PLANS AND DOCUMENTS
referred to in the
DEVELOPMENT APPROVAL

Issued: 11/04/2006
Minor change: 04/06/2026

AMENDED IN RED
4/06/2026

35 Gawler Crescent (35/27)
Bracken Ridge Qld 4017 Lot
35 SP 191 882

SIDE ELEVATION

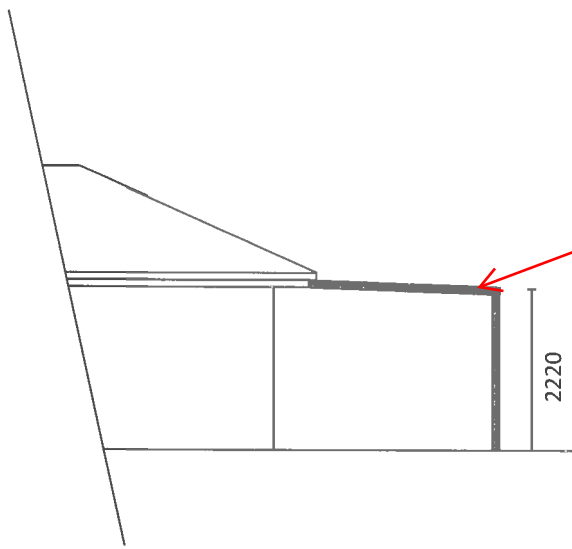
Patio roof structure to
remain open on all
sides
